Notice of Project Change to the Air Rights Garage EEA #8505
and Waterside Place EEA #13367

South Boston Waterfront Transportation Center

**Re: South Boston Waterfront Transportation Center
Notice of Project Change to Air Rights Garage (EEA #8505) and Waterside Place (EEA #13367)**

Figure 3

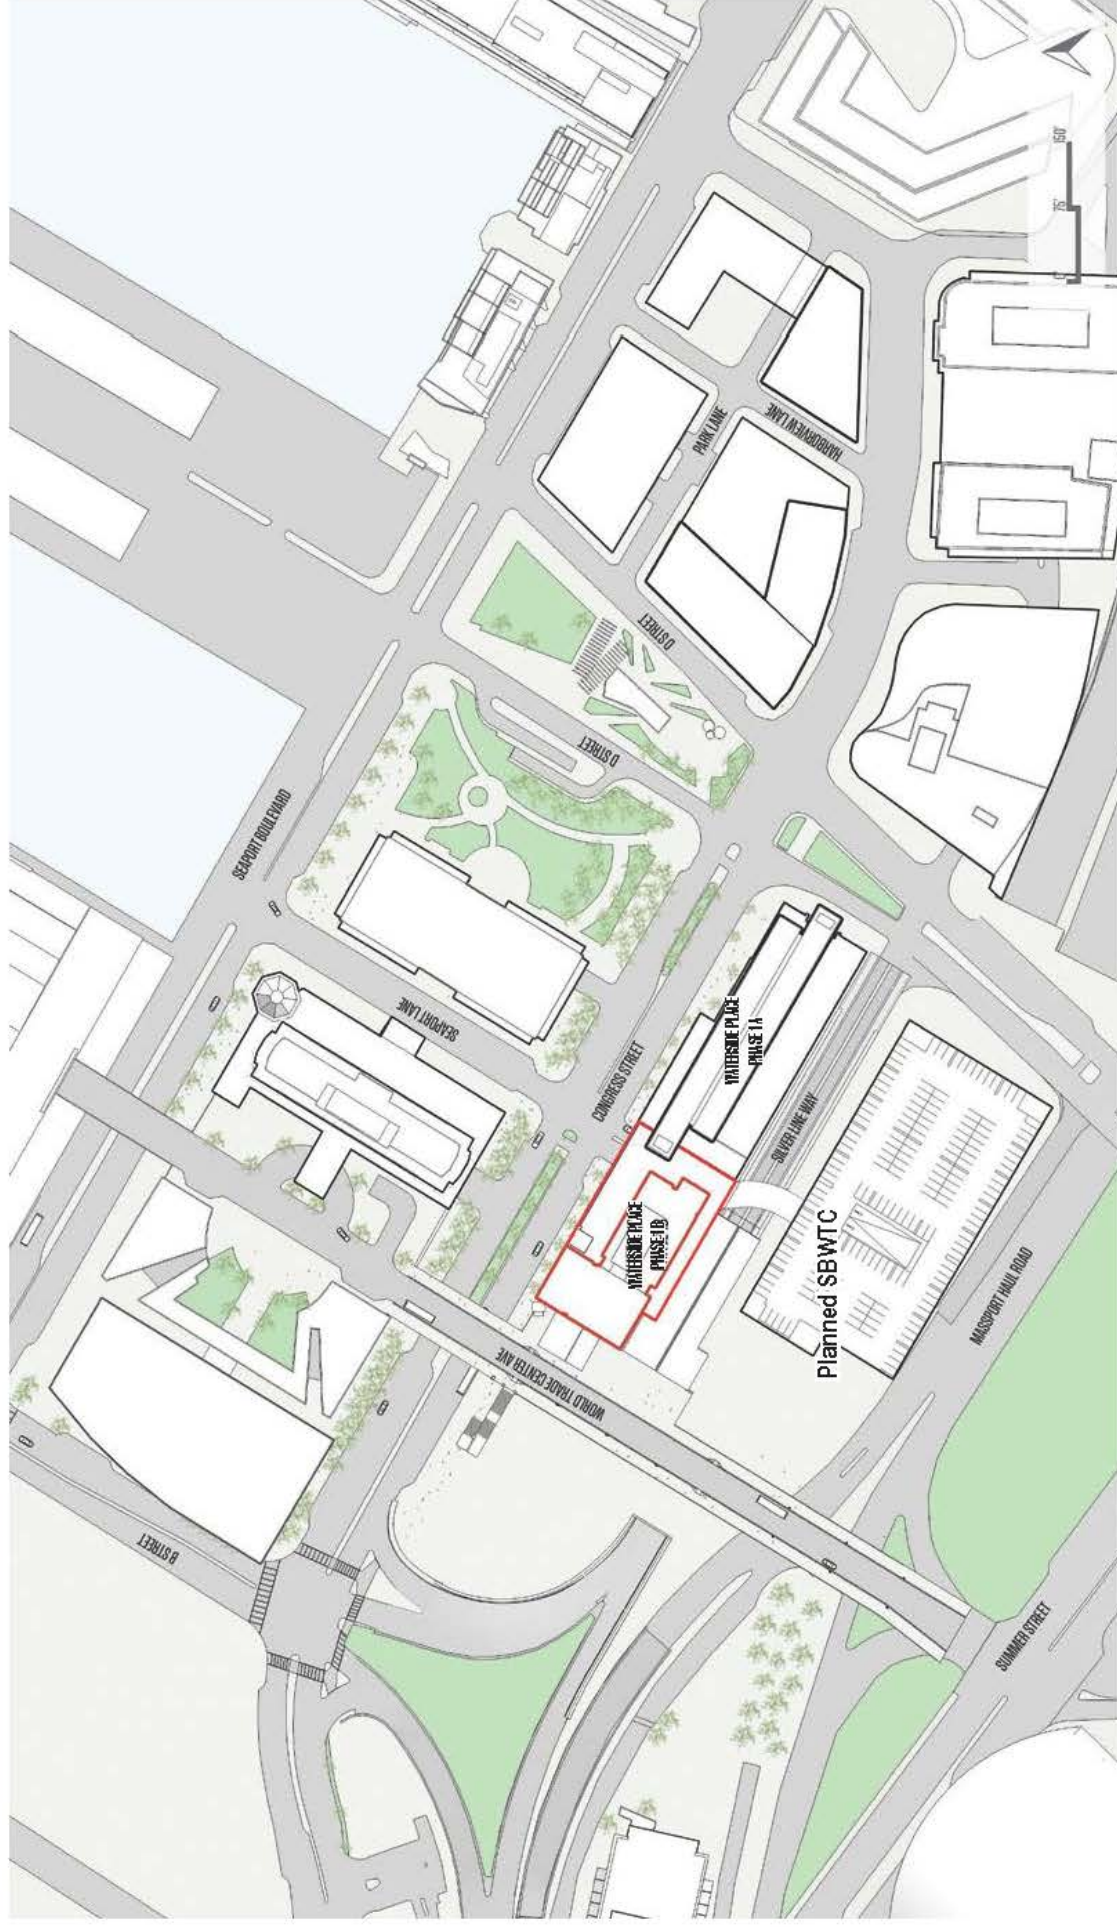
As shown in the site plan presented in **Figure 3, Previously Reviewed Waterside Place Project Phases 1A and 1B**, the SBWTC Project occupies the same general location as the original ARG and the parking component of the Waterside Place project (albeit in a smaller footprint than the latter, due to the reduction in total parking spaces relative to Waterside Place in its entirety). As discussed in more detail in Section 2.0, *Regulatory Context* and illustrated in **Figure 4, CFDA Planning Area**, the SBWTC is located in what was previously referred to as the “Core Block”² of CFDA.

Figure 5
Waterside Place Project
Construction Phasing
**South Boston Waterfront Transportation Center
Boston, Massachusetts**

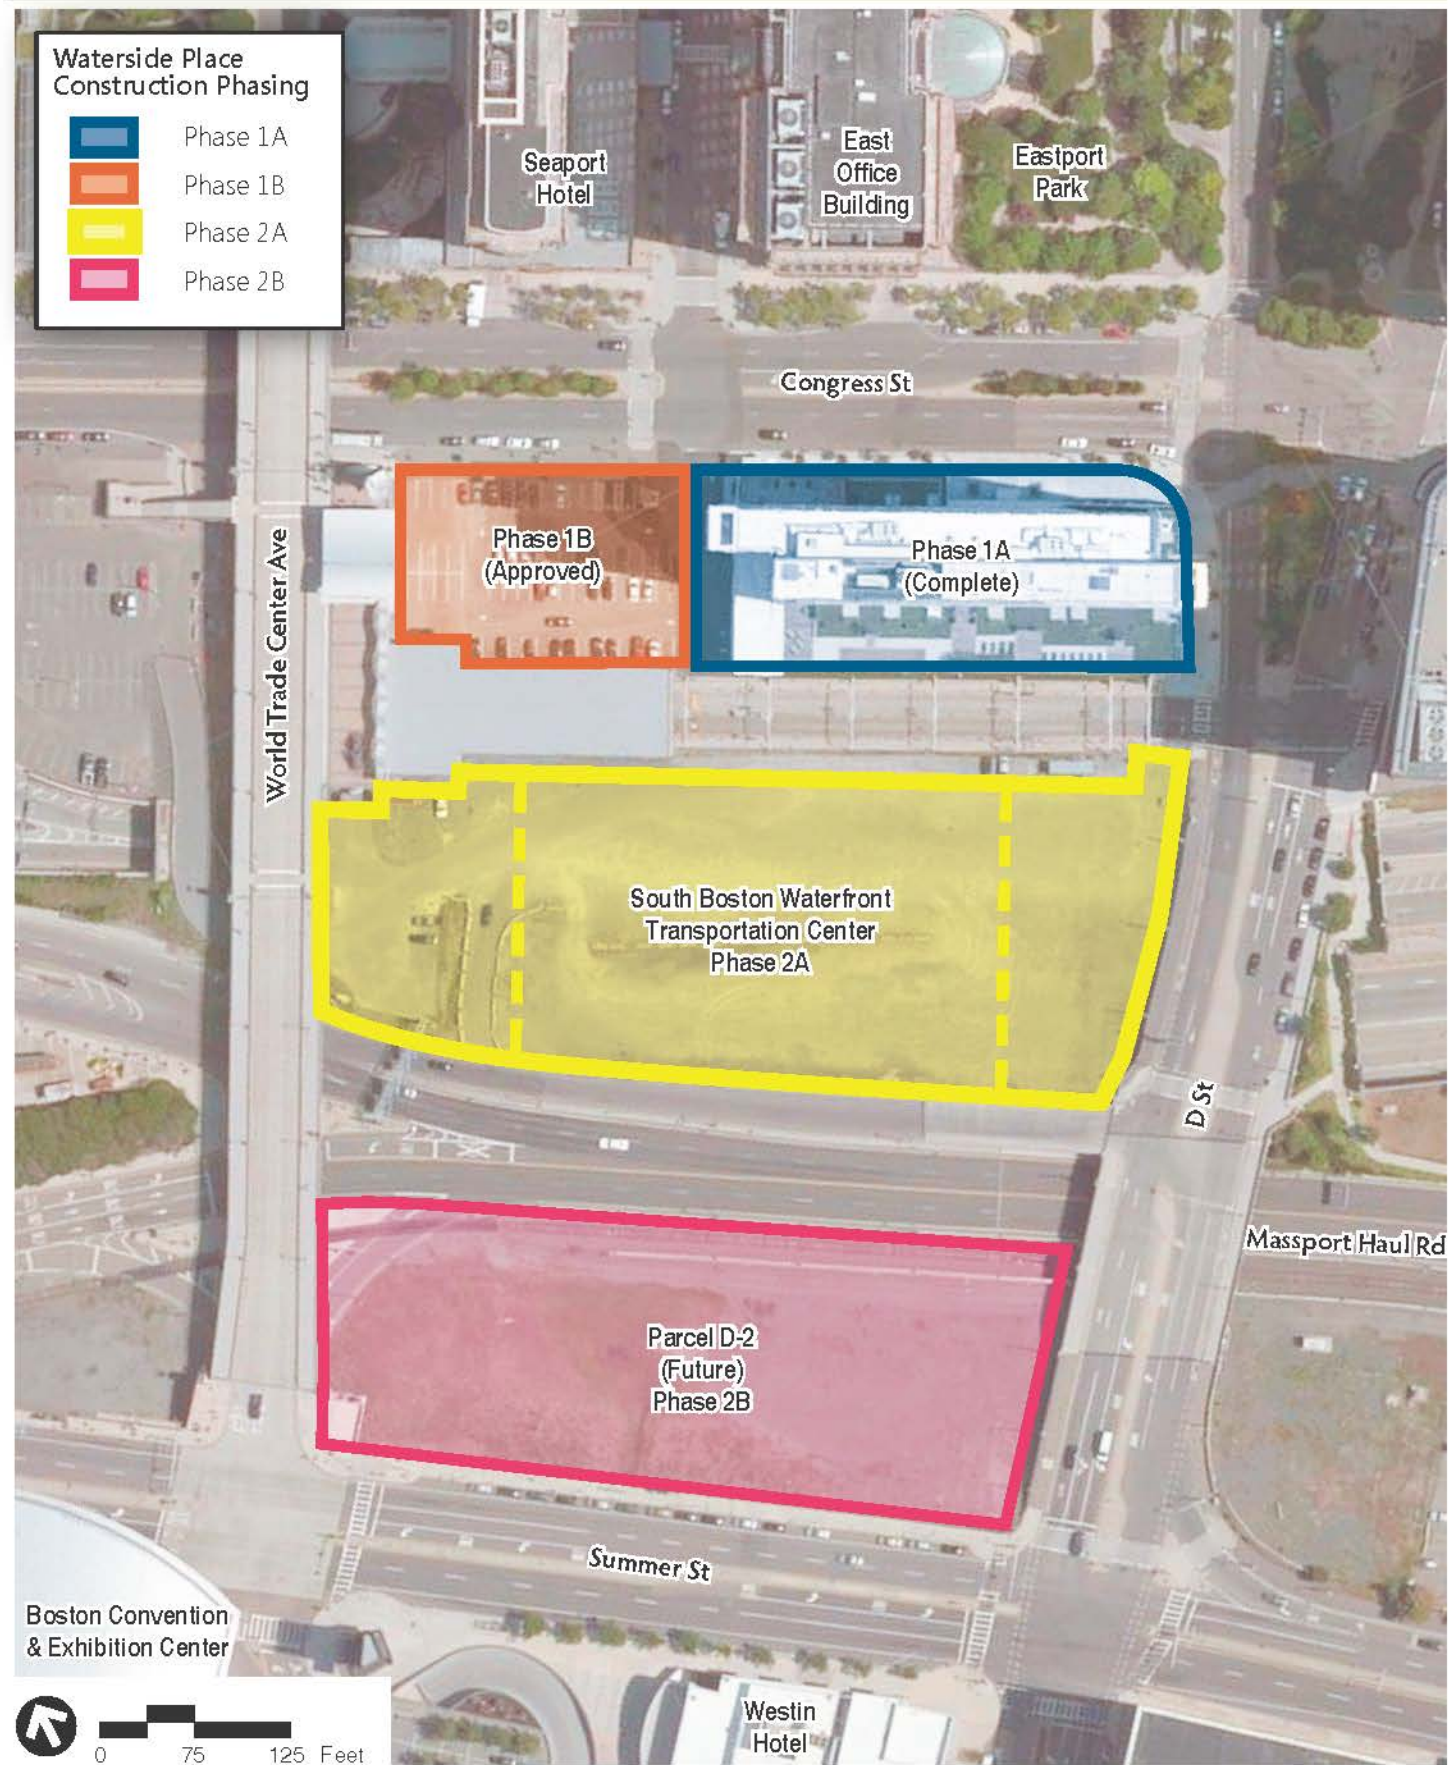
The current phasing for Waterside Place is shown in **Figure 5, Waterside Place Project Construction Phasing**.

Figure 7

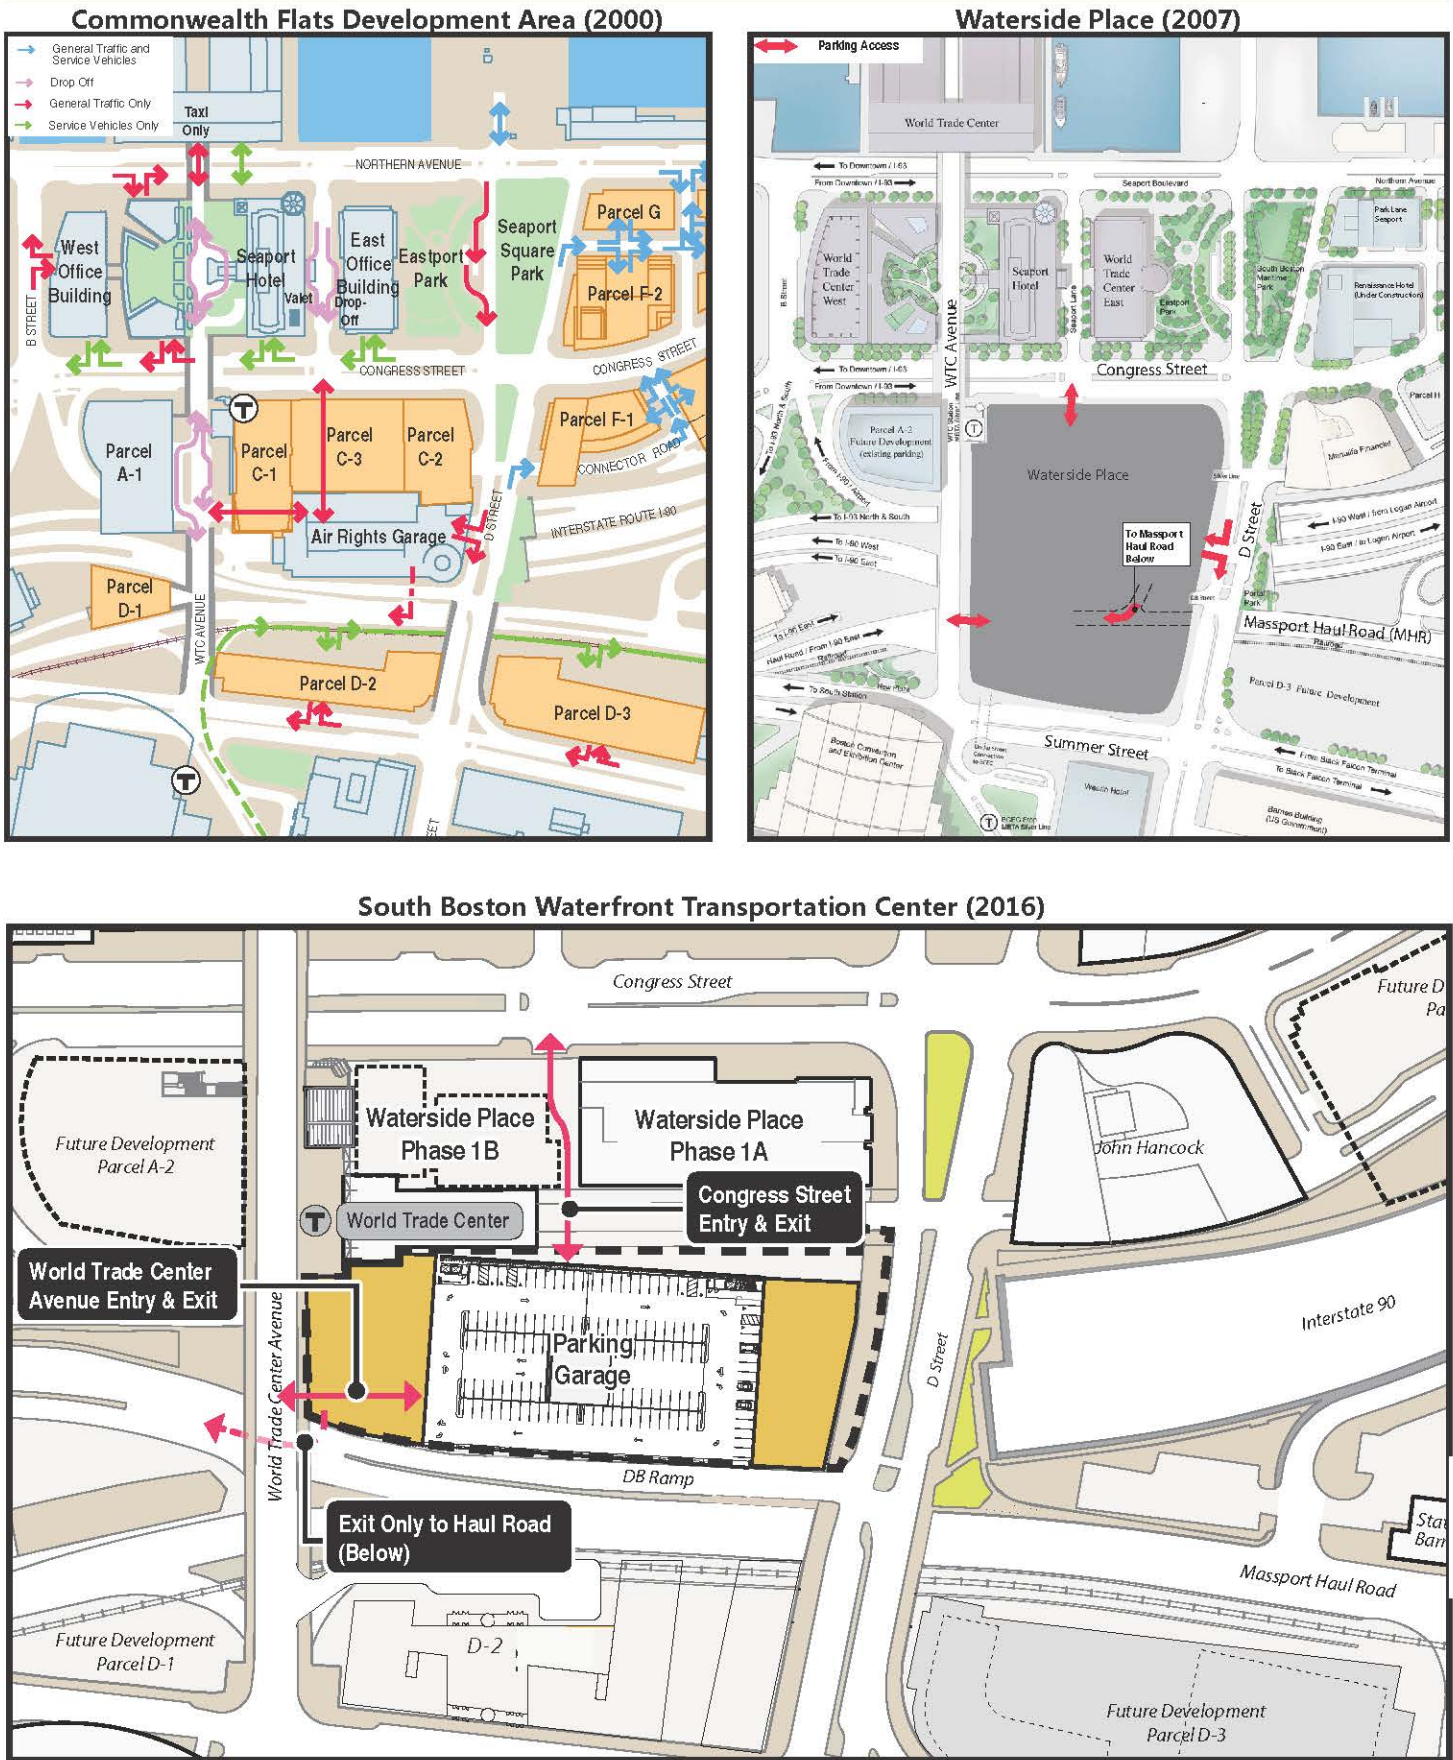
The vehicle access points for the proposed SBWTC are shown in **Figure 7, South Boston Waterfront Transportation Center Vehicle Access**, along with the configurations for the previously approved Waterside Place project and the CFDA. The critical connections to Congress Street and Massport Haul Road are maintained, along with the driveway on WTC Avenue, which provides connections with Summer Street and points beyond. The previous plans also included an access point on D Street. However, this access point has been eliminated in the SBWTC since it would need to be limited to right in/right-out movements due to the median on D Street and is therefore projected to attract very limited use. Its function is adequately provided for by the other vehicle access points, and the integrity of access established throughout Massport's planning is not compromised.
